STAFF REPORT: 3/8/2023 REGULAR MEETING

APPLICATION NUMBER: #23-8239

ADDRESS: 2200 (2600) EAST ATWATER

SCOPE: REPLACE WINDOWS ON ADMINISTRATION BUILDING, ADD VENT

Figure 3, by applicant showing locations of vent installation.

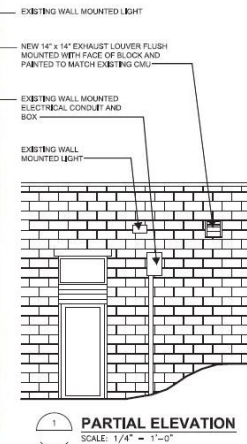
1. 14"x14" exhaust louver, flush mounted with face of block and painted to match existing CMU surface on the exterior.
2. Greenheck ESD-635 extruded aluminum, stationary louver, drainable blade, heavy gauge, 6" thickness (louver depth).

- The Aretha Franklin Amphitheater/Chene Park Historic District, established in December 2019, consists of a 9.3-acre parcel, and is owned by the Detroit General Services Department. The Administration Building is considered to be a noncontributing structure to this district, presumably because it was added to the complex at a later date.
- The proposed outer frames of the windows will be 2" thinner than the existing frames, creating slightly more glazed fixed surface area of the outer windows in each set of the windows.
- The location and design of the proposed installation of the vent does not detract from the building's features, in staff's opinion.

It is staff's opinion that the proposal to replace the windows, install the vent and paint the building is appropriate. Staff therefore recommends the Commission issue a Certificate of Appropriateness for the work as proposed because it meets the Secretary of the Interior Standards for Rehabilitation and the district's Elements of Design.

Figure 4, by applicant showing existing window frame dimensions in blue and proposed frame dimensions in black.

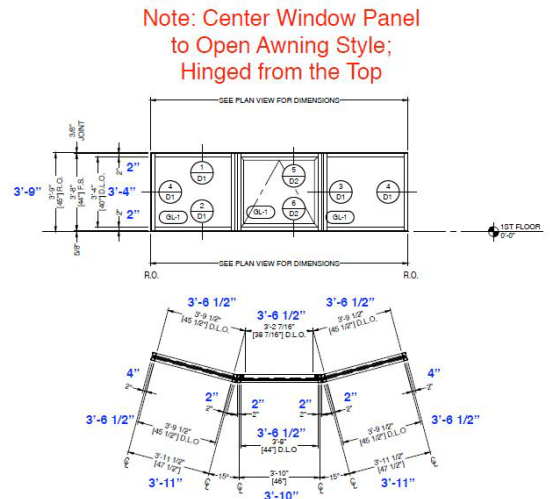
1. Each current ribbon of windows consist of three fixed panes. The proposed windows would have two outer fixed panes with a center awning operational pane. This would permit fresh air to enter the administrative working areas.
2. All panes would be painted to match existing trim, deep lagoon (blue) color.
3. The windows are 4500/4600 WOJAN series commercial aluminum fixed and awning windows, clear glass anodized finish.
